# 162 Queens Quay East

Detailed Design

Review Stage: Detailed Design

# May 2019 DRP- Consensus comments

### 03 | SITE MASSING

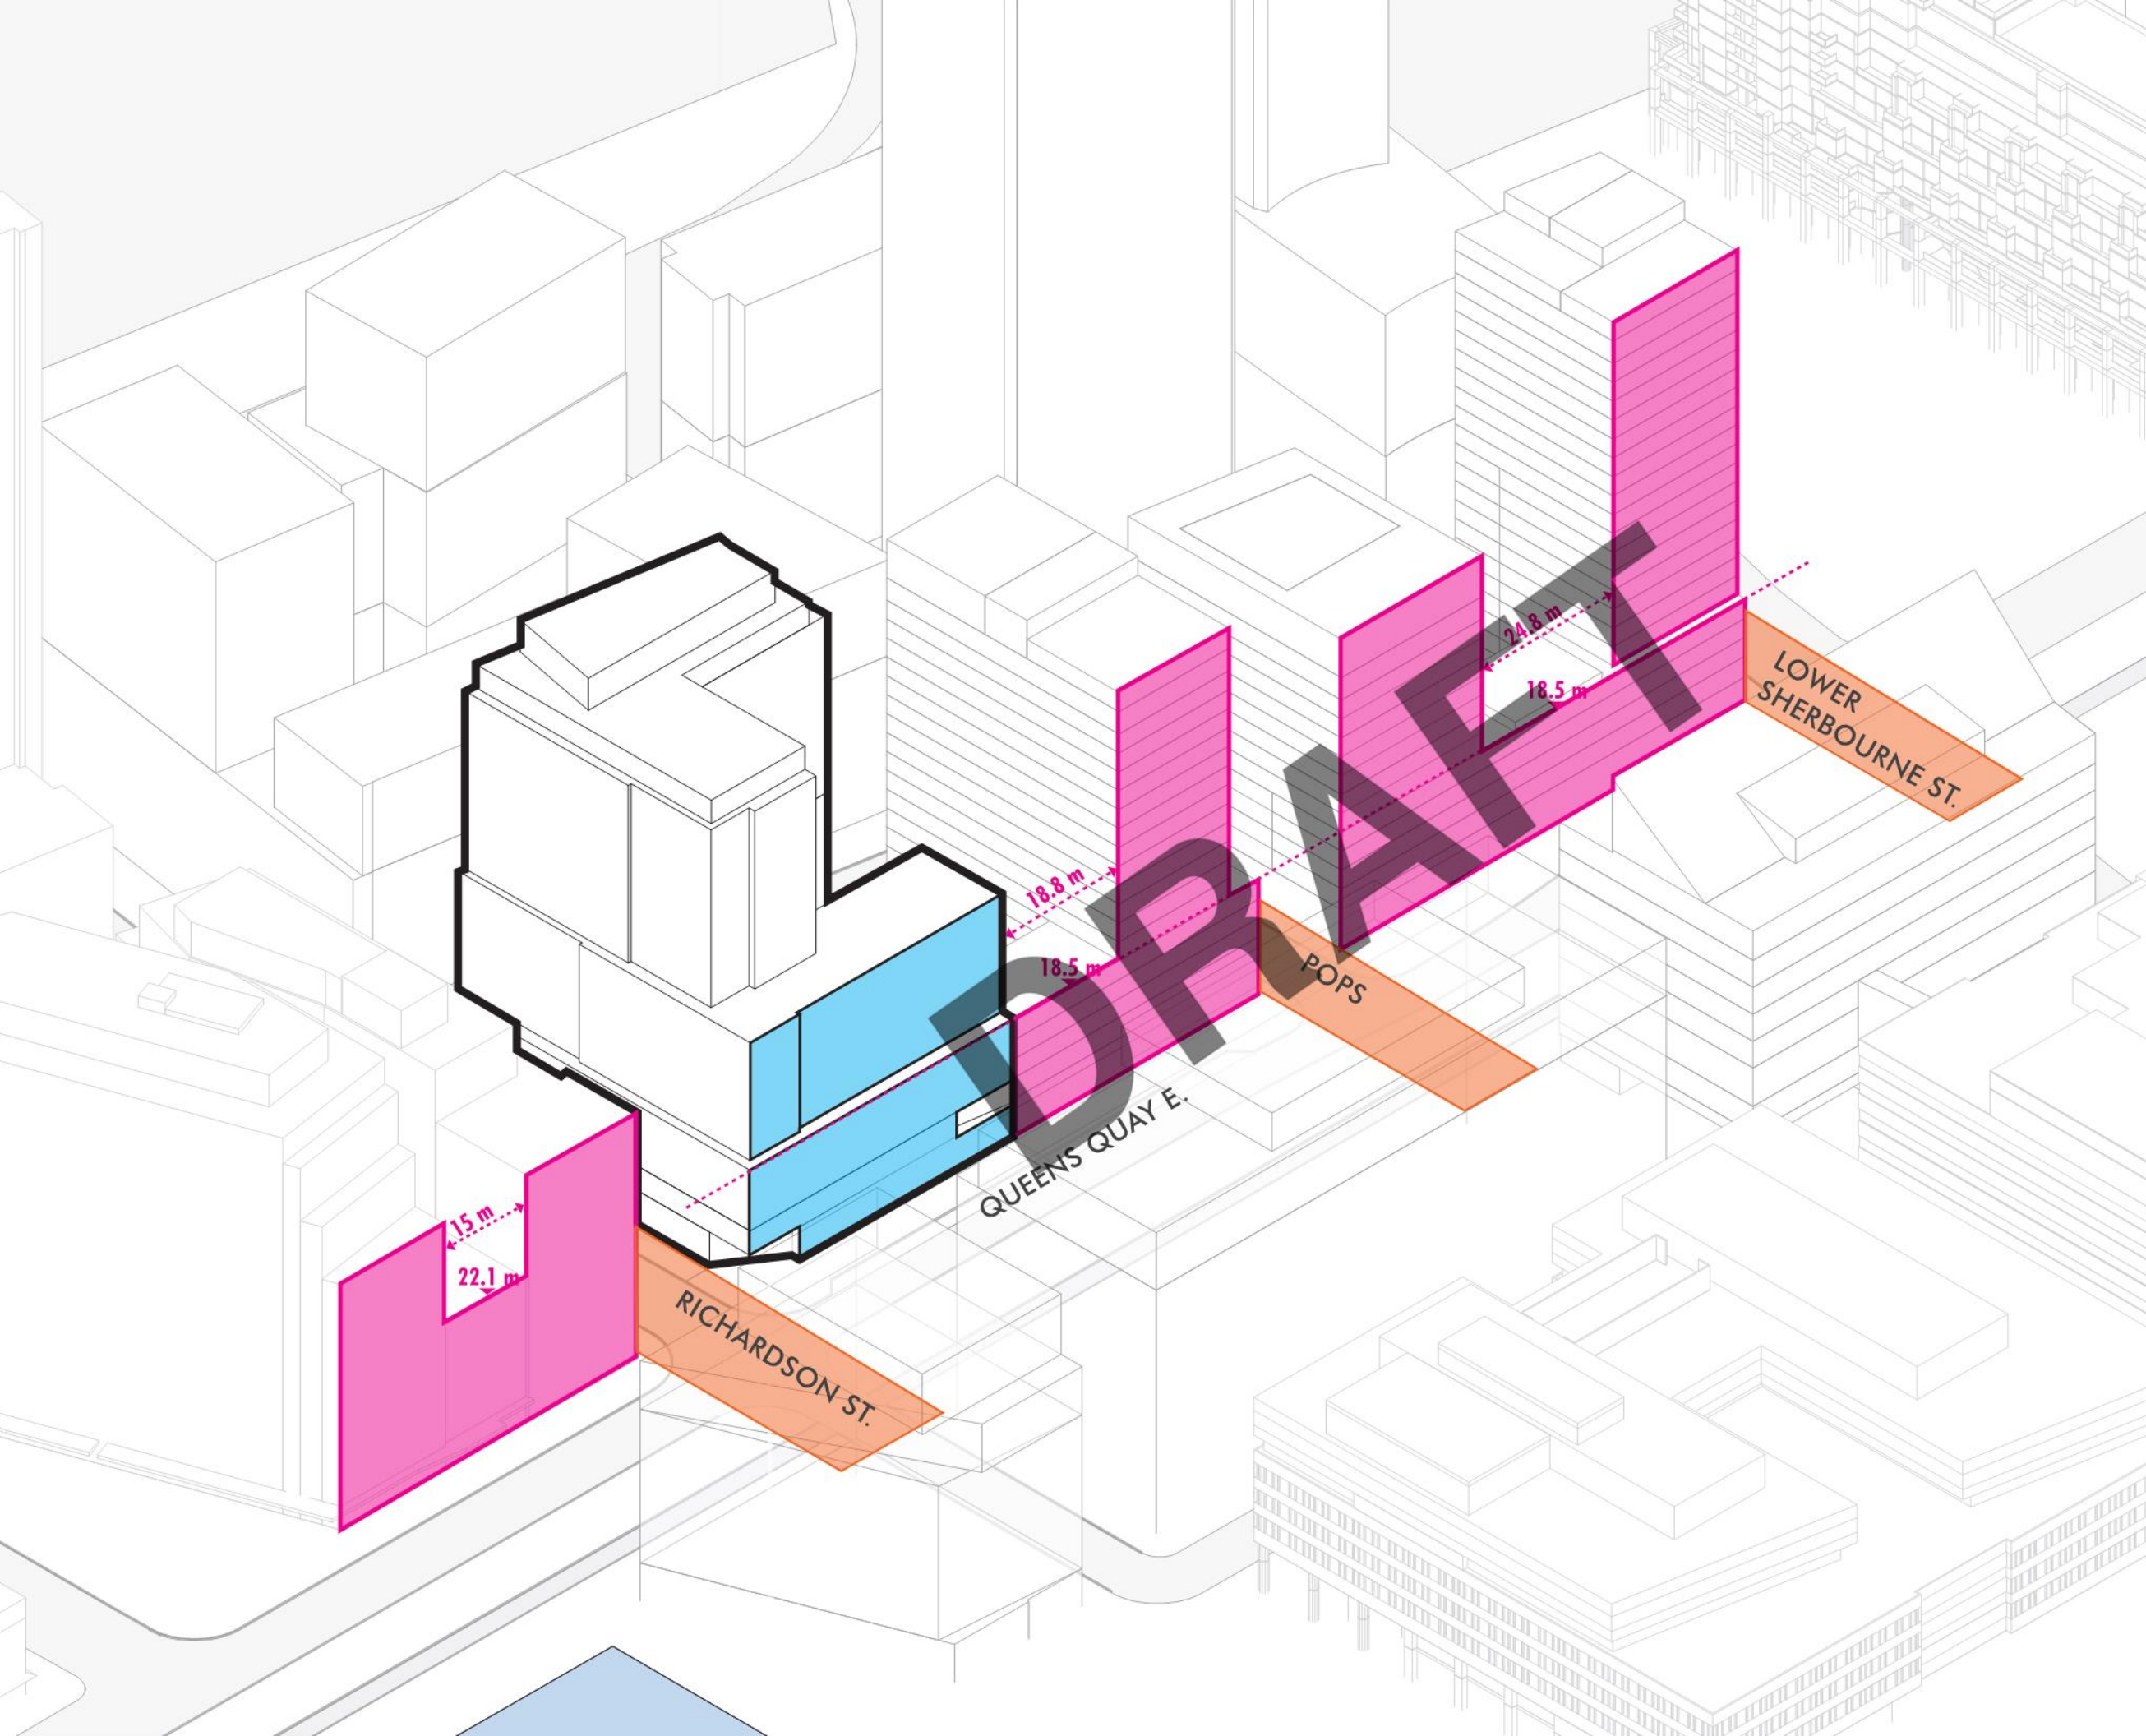
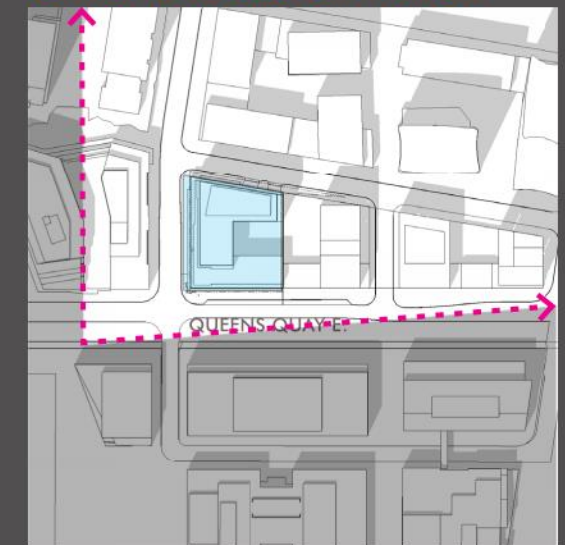
\*made during 178 Queens Quay E.  
1st DRP Meeting, July 24, 2019

- Consider a setback along the southeastern wing of the building (adjacent to 178 Queens Quay East) to create a larger setback between buildings.

- The distance between the buildings fit within the overall pattern and context of Queens Quay. The current separation distance is larger than that of Daniels to the East, and provides a smooth transition to the larger separation distance between the 178 Queens Quay East center and eastern tower.

STREET SECTION

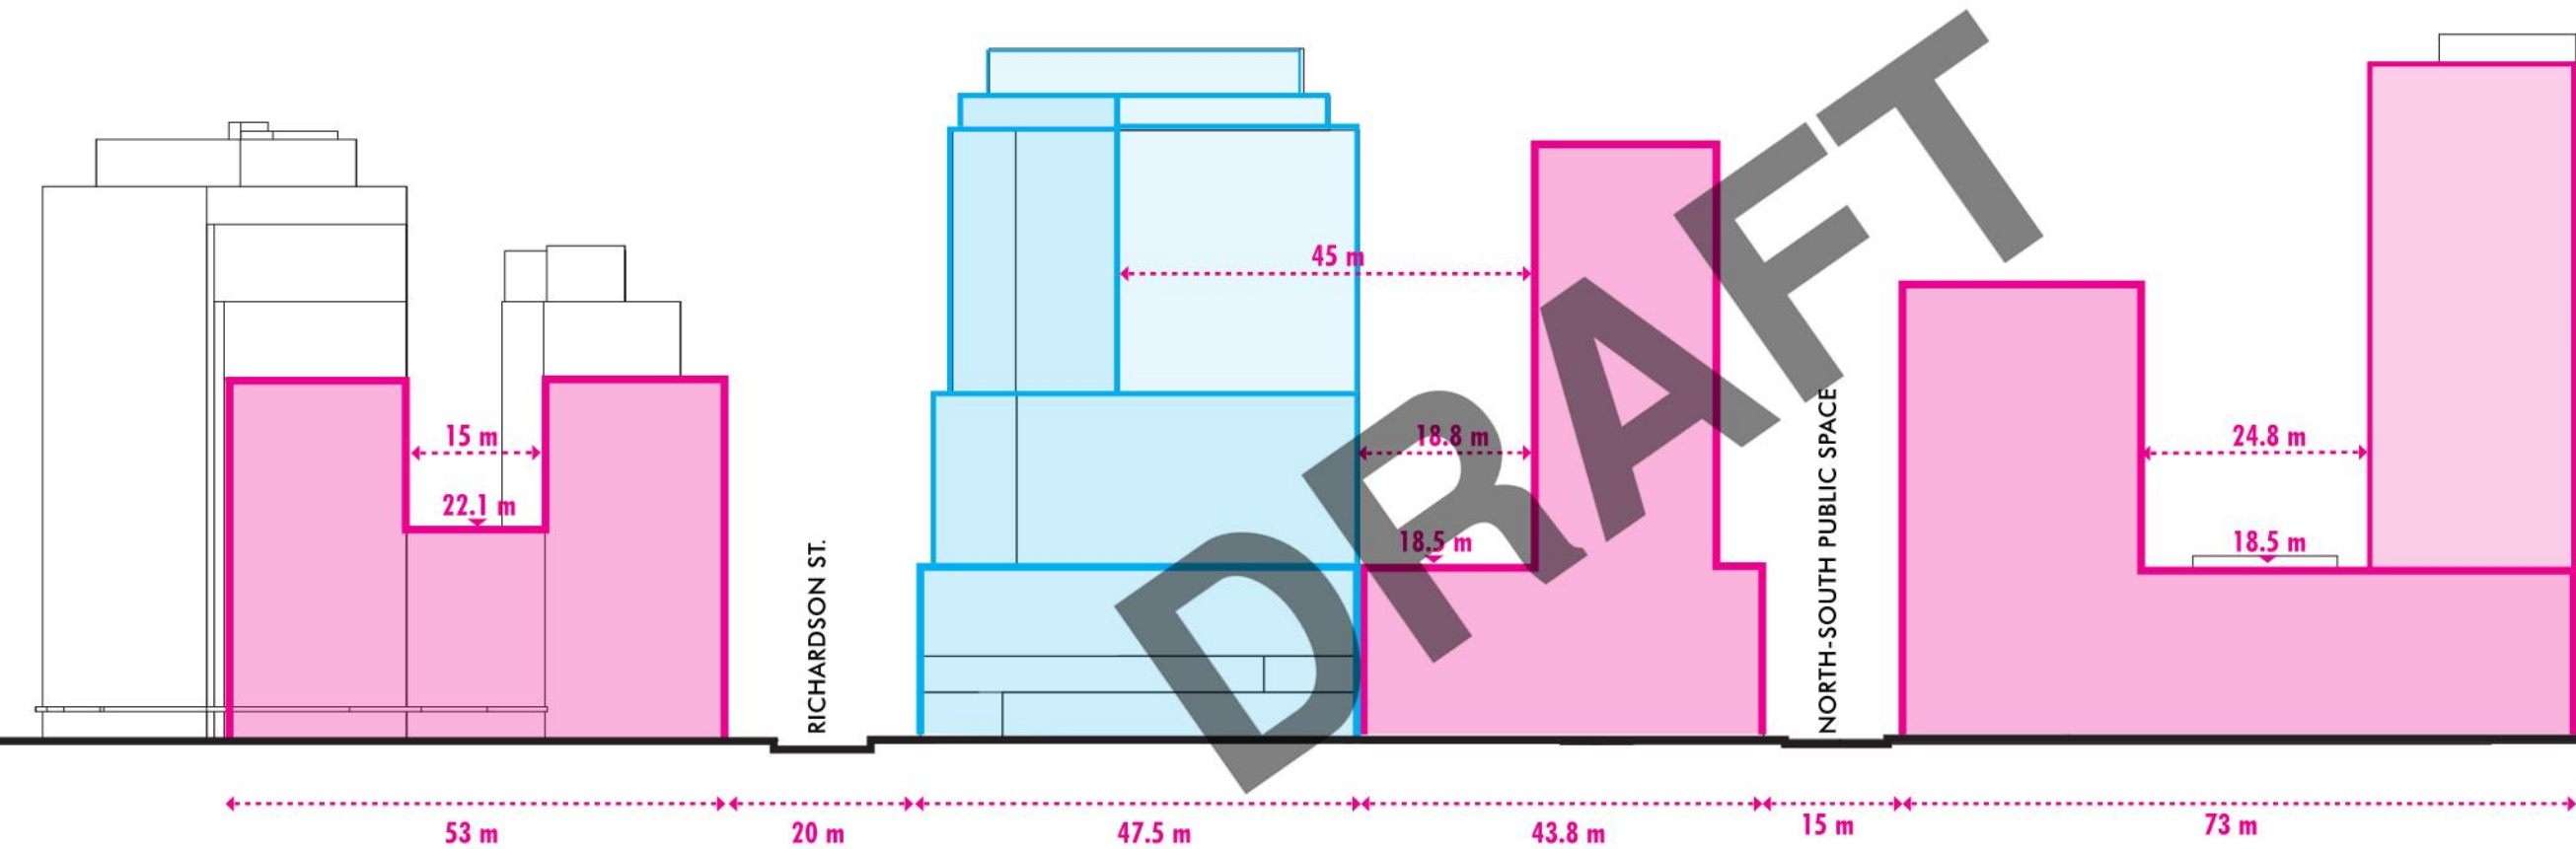
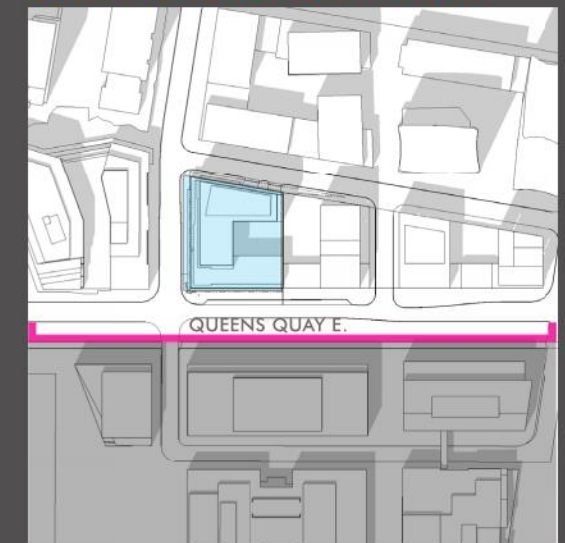
\*made during 178 Queens Quay E.  
1st DRP Meeting, July 24, 2019

- Consider a setback along the southeastern wing of the building (adjacent to 178 Queens Quay East) to create a larger setback between buildings.

- The distance between the buildings fit within the overall pattern and context of Queens Quay. The current separation distance is larger than that of Daniels to the East, and provides a smooth transition to the larger separation distance between the 178 Queens Quay East center and eastern tower.

### 03 SITE MASSING STREET SECTION

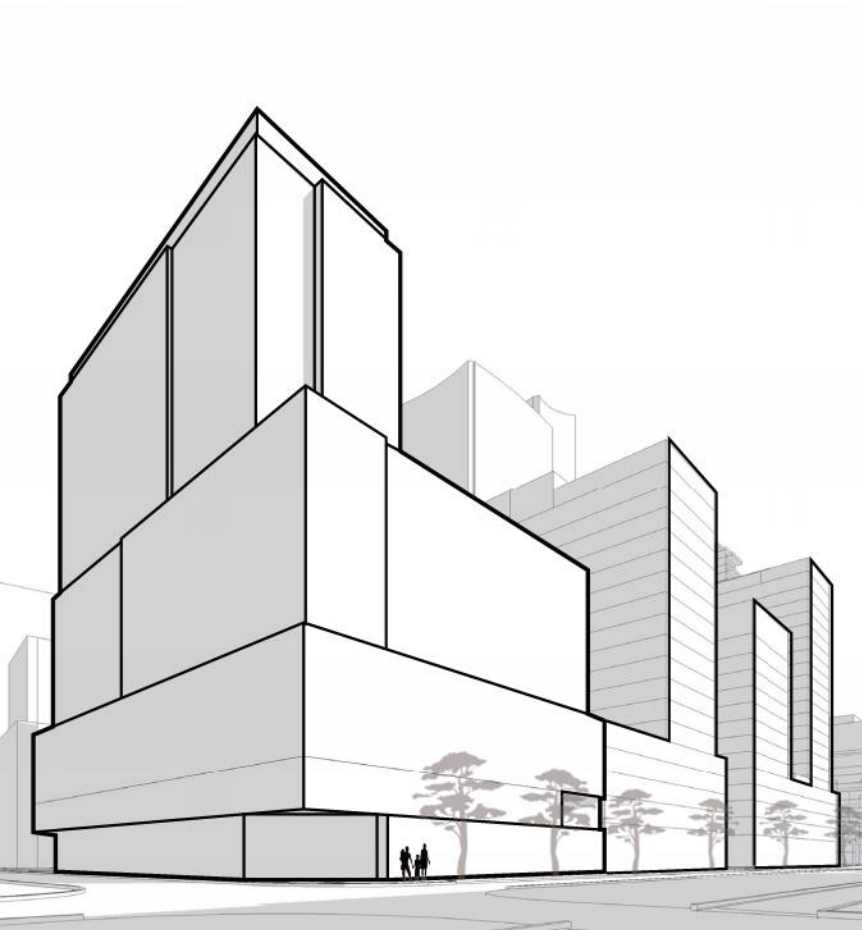
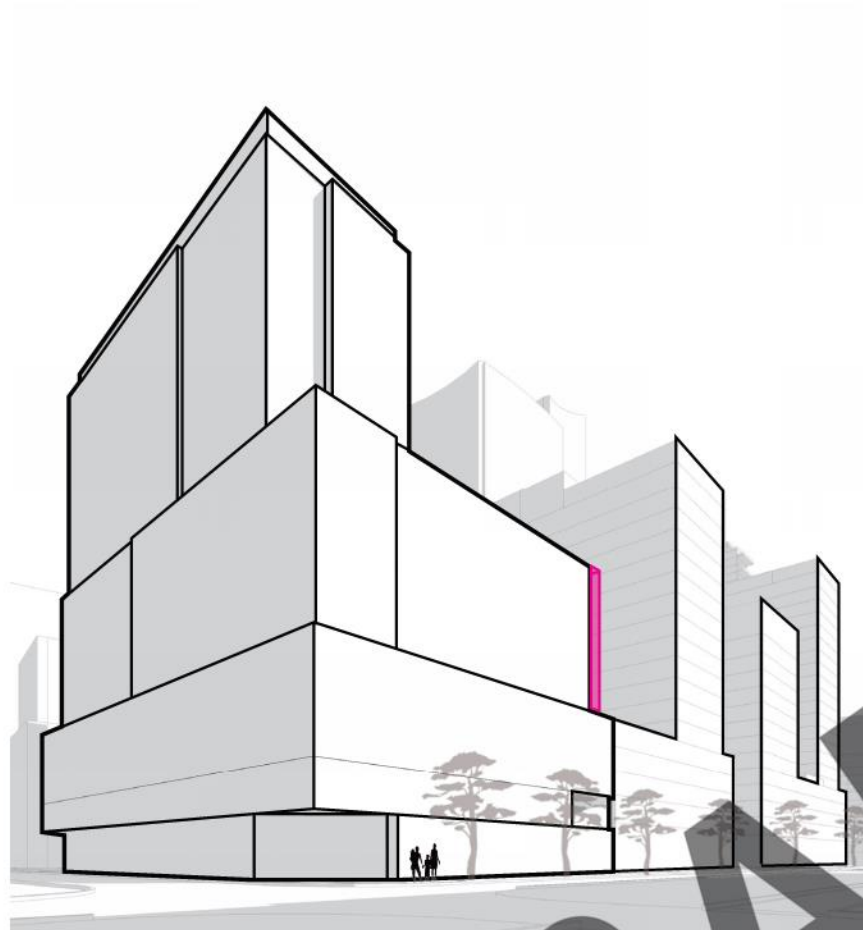
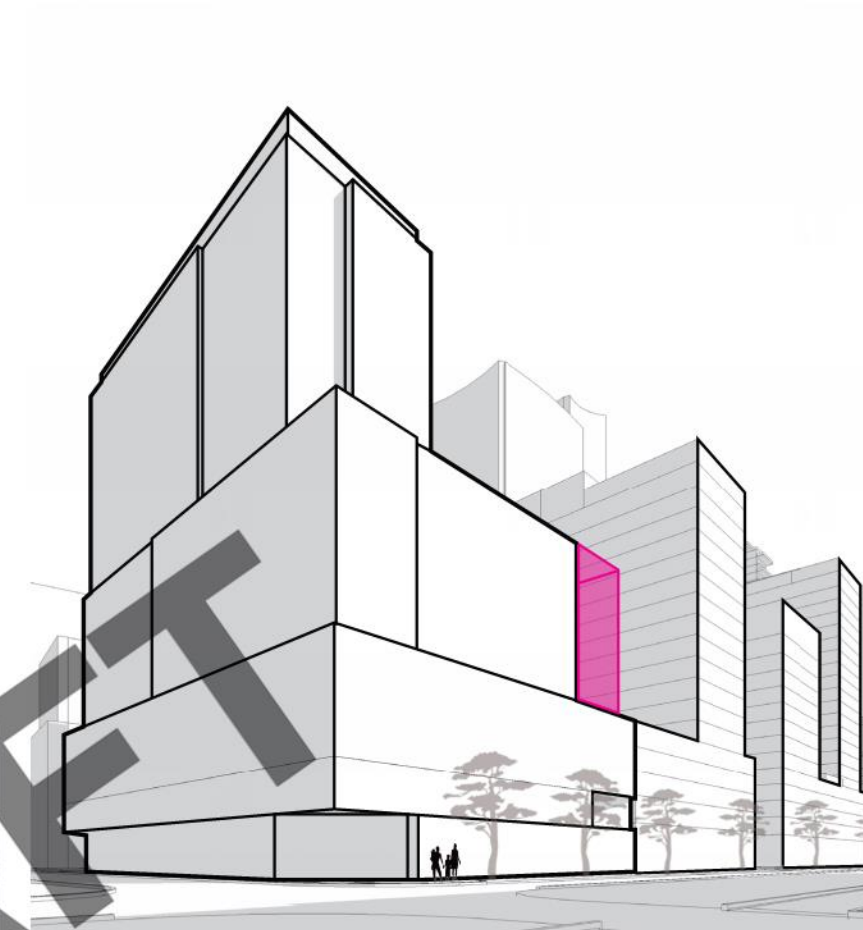
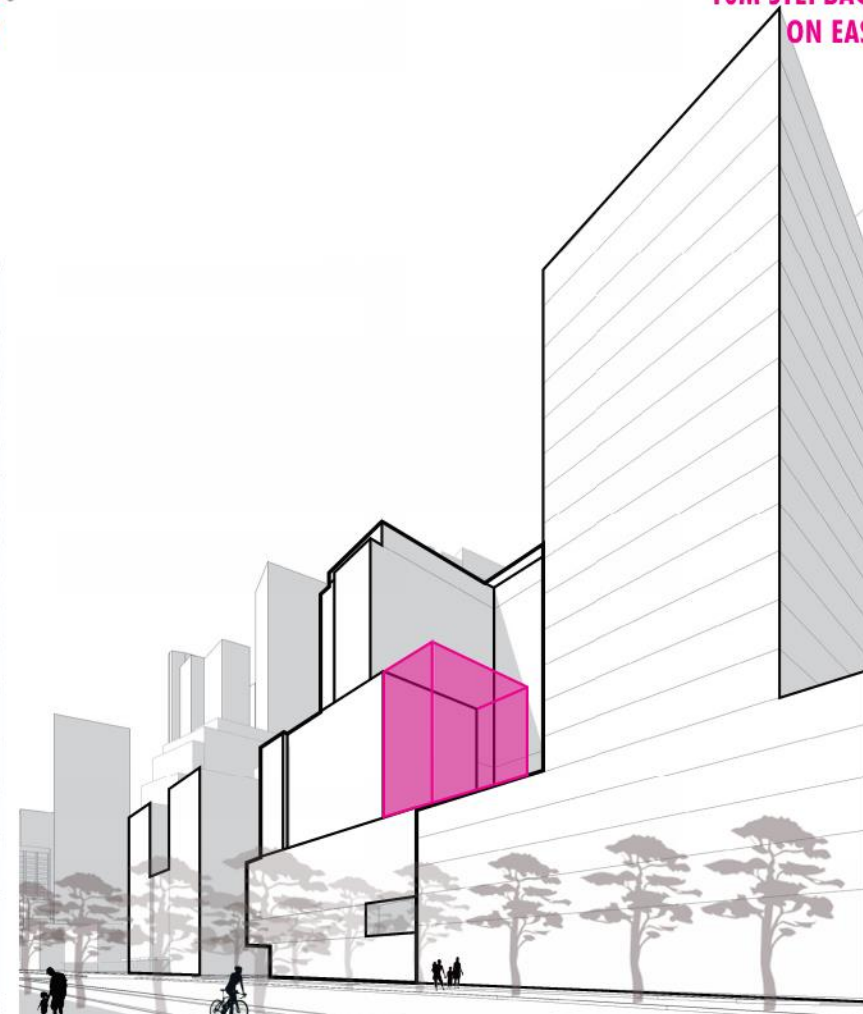
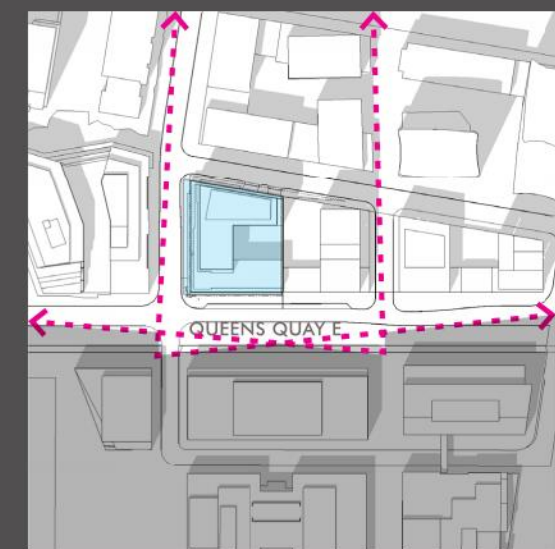
\*made during 178 Queens Quay E. 1st DRP Meeting, July 24, 2019

- Consider a setback along the southeastern wing of the building (adjacent to 178 Queens Quay East) to create a larger setback between buildings.

- A 2m setback on the eastern portion of the podium would not create a noticeable impact. A 10m setback would create a significant loss in GFA that would ultimately need to be added to the top of the building, increasing overall height and storeys.
